Record of Decision
O&R Port Jervis Former MGP Site
Port Jervis (C), Orange County, New York
Site Number 3-36-049

December 2007

DECLARATION STATEMENT - RECORD OF DECISION

This responsiveness summary responds to all questions and comments raised during the public comment period. The following are the comments received, with the Department's responses:

FIGURE 2
Historic MGP Structures

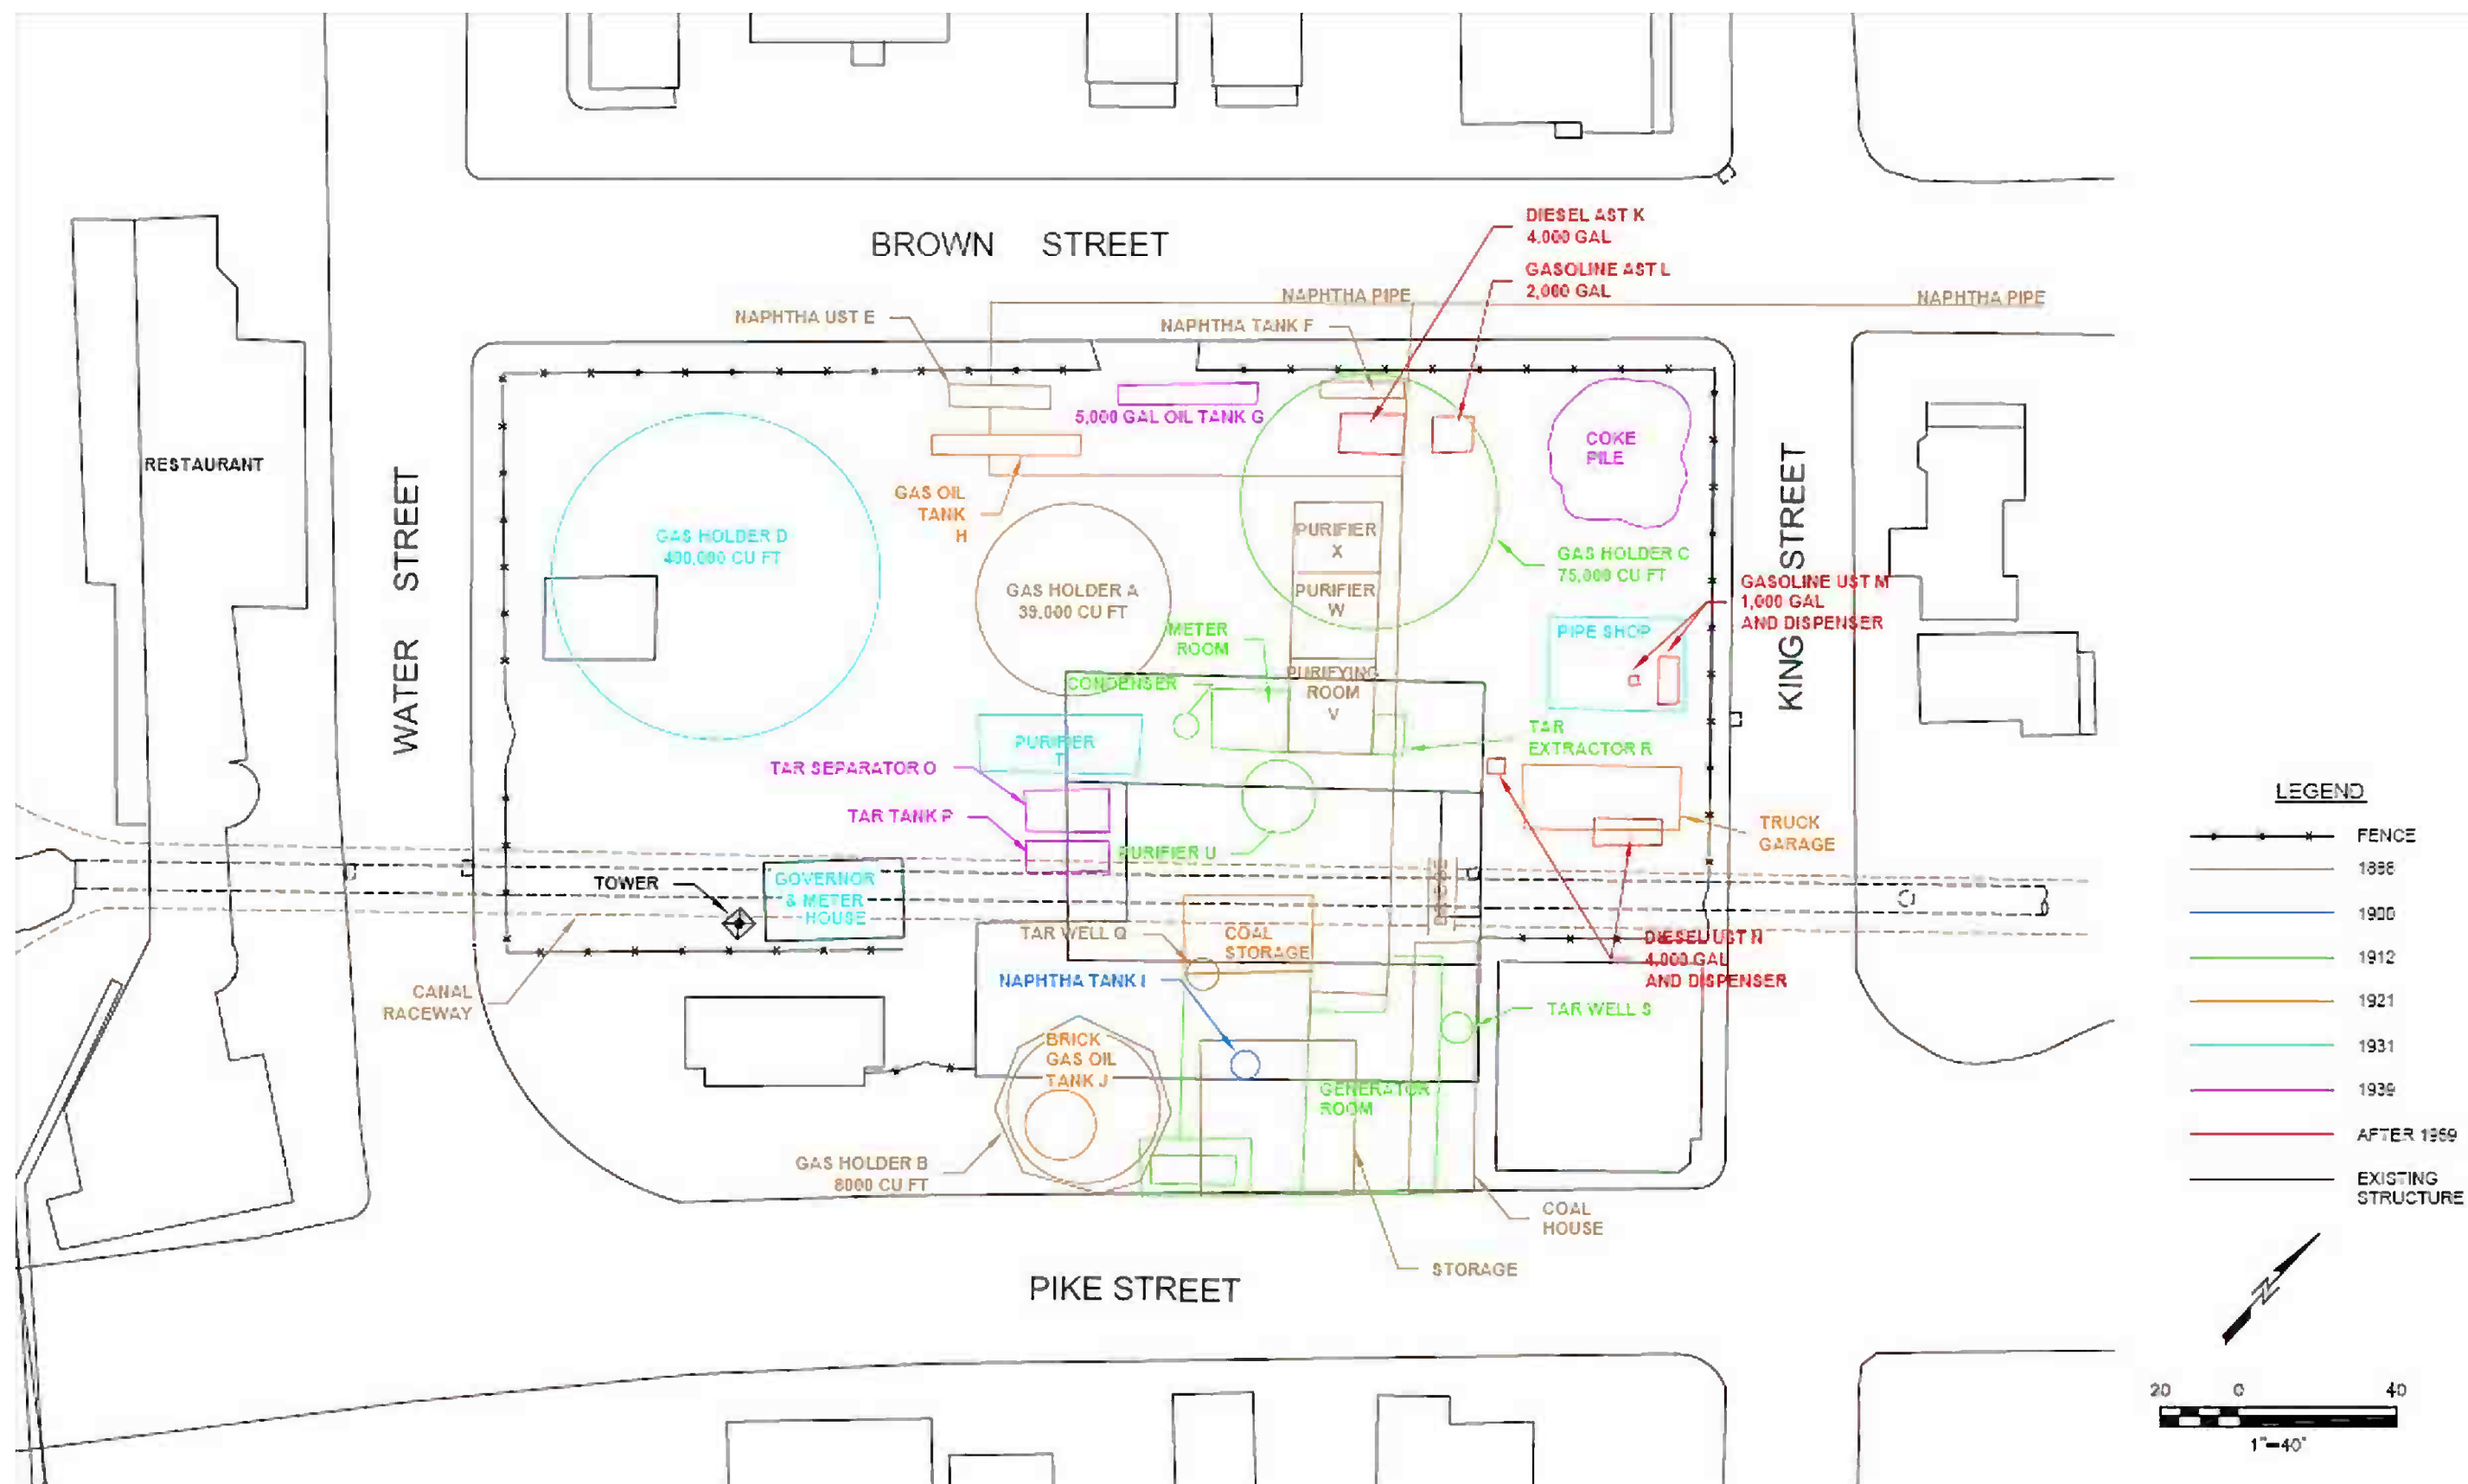
COMMENT 36: My property and business are located on part of the old gas plant and are in the same location as a former coal house. Other MGP-related buildings or structures, including Tar Well S, were located within two feet of my building and may have been partially on my property.

RESPONSE 36: Mr. Codichini, the owner of the property at 28 Pike Street, has stated that his building was constructed in 1880. Historic maps for the City and site area (including Sanborn maps which date from 1888 to 1945) show a building at 28 Pike Street that appears to be the same building that exists today. According to these maps, the coal house existed contemporaneously with the building at 28 Pike Street, and the coal house is depicted to the southwest of the building at 28 Pike Street. Therefore, the best approximation of the location of the coal house would not place it on Mr. Codichini's property. The approximate location of the coal house has been corrected on figures included in the ROD.
